NUREG/CR-1870  
SAND80-2869

# V. C. Summer Nuclear Station Unit 1 Emergency Feedwater System Reliability Study Evaluation

The purpose of this report is to present the results of the review of the Emergency Feedwater System Reliability Analysis for the V. C. Summer Nuclear Station Unit 1.

FIGURE 2 AC POWER DISTRIBUTION TO EFS COMPONENTS

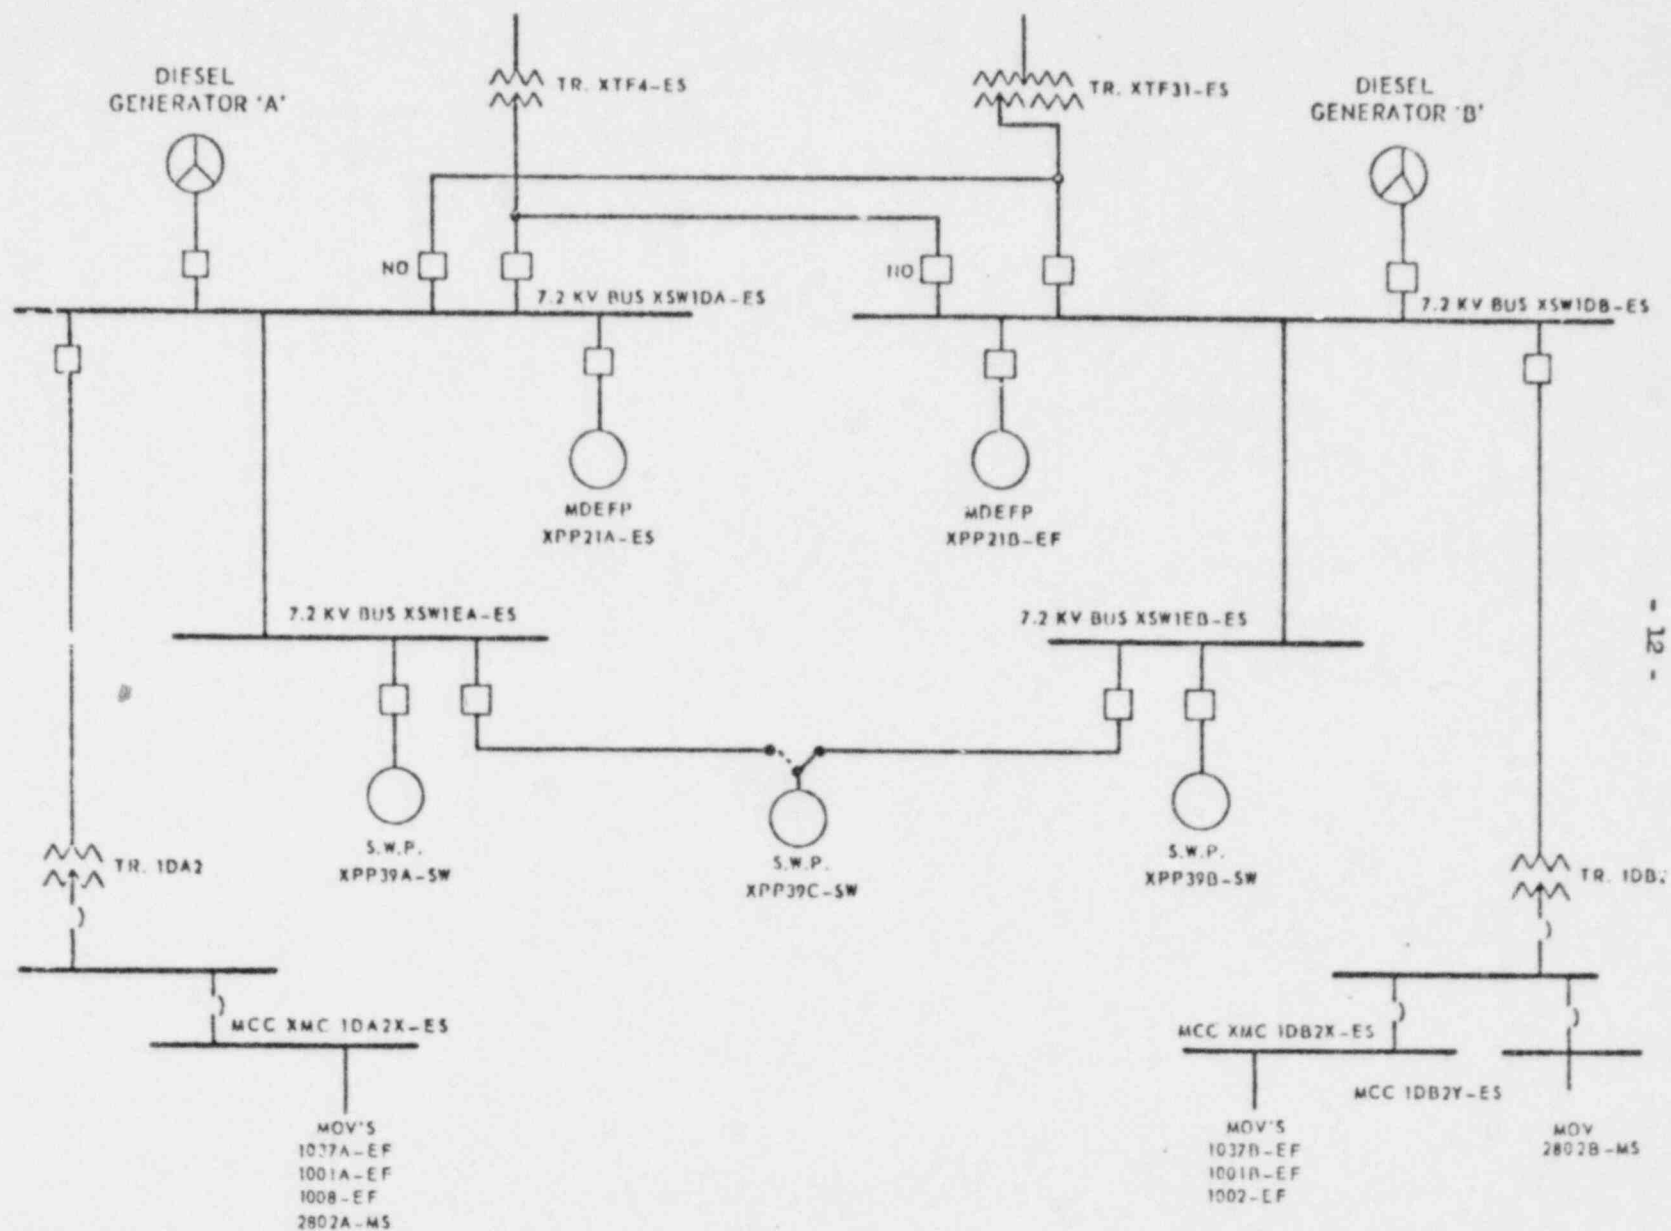
At Summer the motor driven EF pumps are supplied with power from different buses which are, under a Loss of Offsite Power condition, powered from the diesel generators. This arrangement is shown in Figure 2. This figure also shows which motor operated valves are powered from these buses. A description of the separation criteria for redundant electrical systems is contained in PSAR Section 8.3.1.4. Separation of power systems is necessary to eliminate common cause failure events from reliability considerations. In doing so EFS reliability is increased. The Summer system is considered adequate.

FIGURE 4 COMPARISON OF V.C. SUMMER UNIT 1 EFS RELIABILITY WITH THAT OF OPERATING WESTINGHOUSE PLANTS

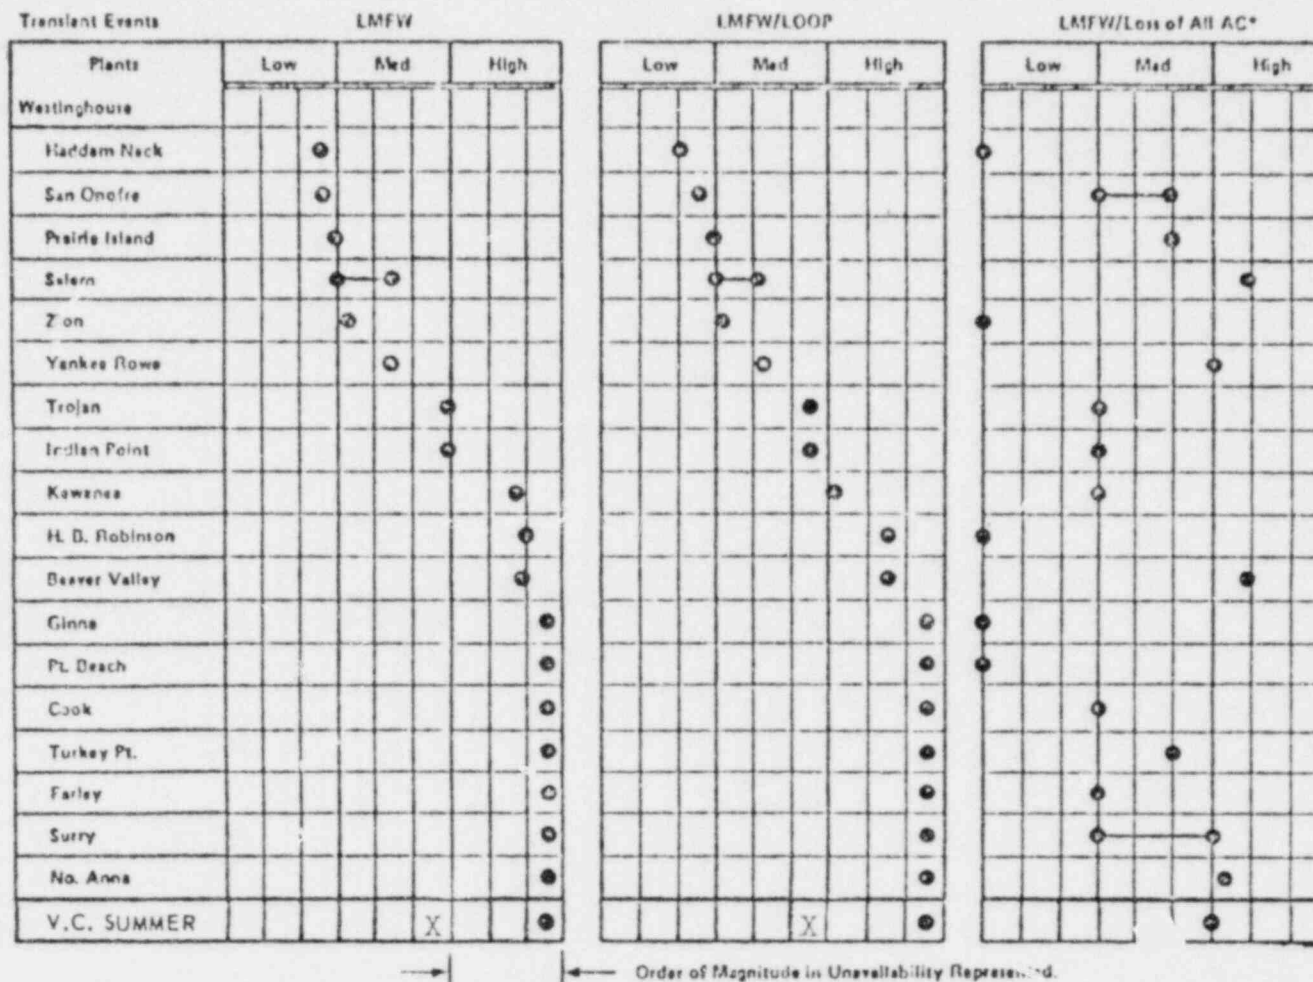
The basic report<sup>(2)</sup> did not contain a table which included all fault tree events. The revision<sup>(5)</sup> to the report did and most data was taken from NUREG-0611. The first order event data deviated from that presented in NUREG-0611 and the reasons for such deviations were explained. The first order event contributed a major portion to the overall system reliability and therefore changing its assessment made comparison to other similar operating plants as shown on Figure 4 less meaningful.

A very rough numerical estimate of the reliability reported by Summer is derived from Figure 4. For Case 1 the failure probability is  $1.2 \times 10^{-5}$ ; for Case 2  $1.2 \times 10^{-5}$ , and for Case 3  $1 \times 10^{-2}$ .

The events describing valve 1010 are assessed by SCE&G to be  $1 \times 10^{-5}$ .\* Therefore for Case 1 and 2 the remainder of the system contributes a small amount in comparison. Extracting values for the individual contributors for Case 3 as listed above was not attempted.

\*SNL does not agree with this assessment since NUREG-0611 gives a value of  $1 \times 10^{-4}$  for valves being plugged. If  $1 \times 10^{-4}$  were used this would shift the Summer rating on Figure 4 from the high to medium range for Case 1 and 2.
